# PROSECUTION TEAM PRESENTATION

Proposed Cleanup and Abatement Order, PG&E Hinkley

Lahontan Water Board Prosecution Team November 4, 2015 Water Board Meeting

Lower Aquifer Background Concentrations

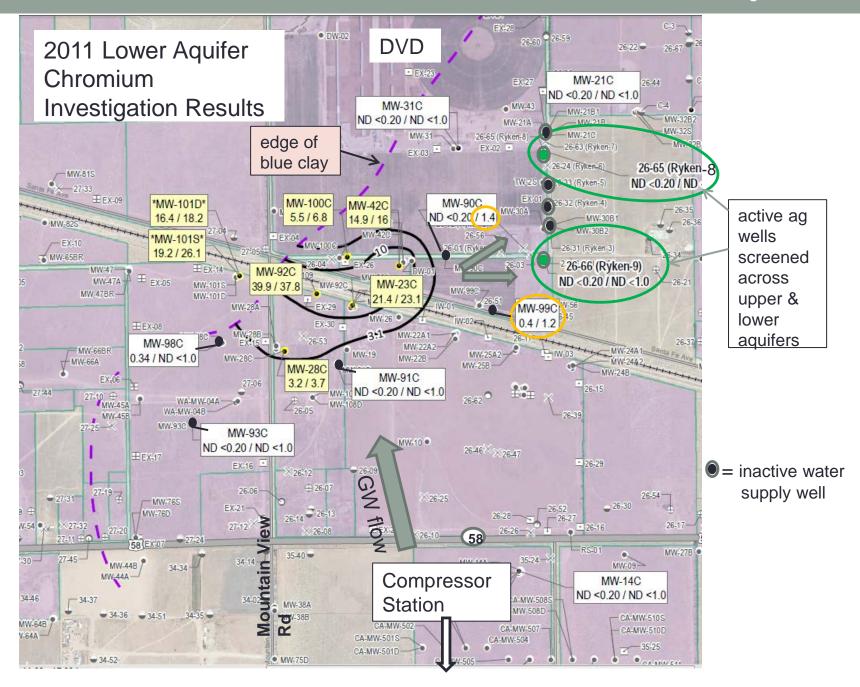
- Conceptual Site Model previously put forth by PG&E; no need to develop additional model
- Sufficient data exist to establish background values in Lower Aquifer including "localized area"; no need to collect additional data or delay a decision
- Four of five MWs up- or cross-gradient to Lower Aquifer plume in "localized area" have shown non-detect (at 0.2 ppb) for Cr6 for years
- Actions have already resulted in cleanup to less than 0.2 ppb
- Recommend incorporating background value for Lower Aquifer of 0.2 ppb into CAO

Plume Mapping and Best Professional Judgment

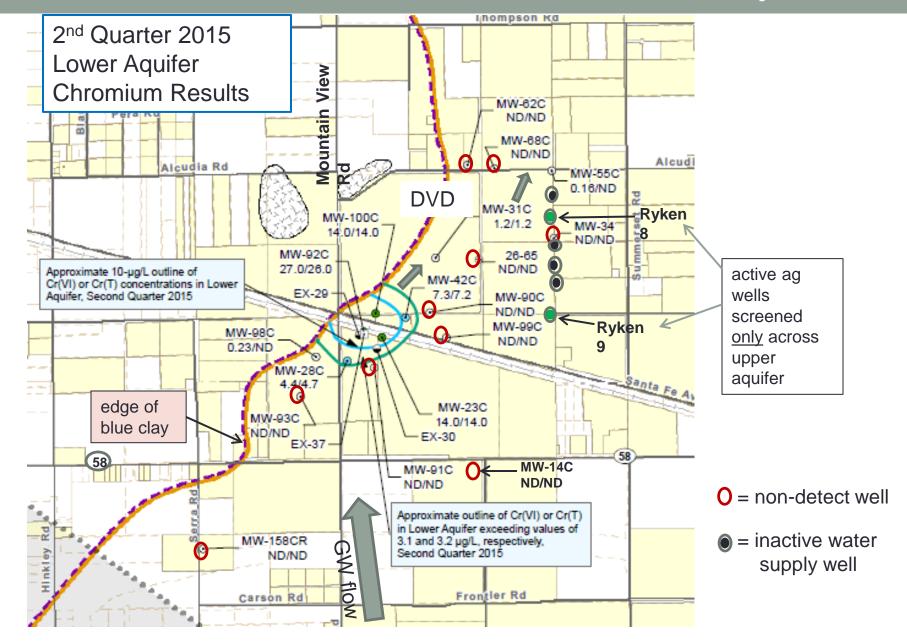
- BPJ maps led to confusion and contention in past; Water Board staff and PG&E developed effective compromise method - "inset maps" with explanatory text, in use for 1.5 years
- Provides consistent and comparable maps adding clarity to public perception of progress and Water Board regulatory efforts
- PG&E, in September 30, 2015 comments, indicated willingness to continue "inset map" method
- ➤ Recommend retaining mapping requirements from CAO R6V-2008-002A4 which requires drawing plume lines connecting monitoring wells with chromium detections >/= 3.1/3.2 ppb within 2,600 feet
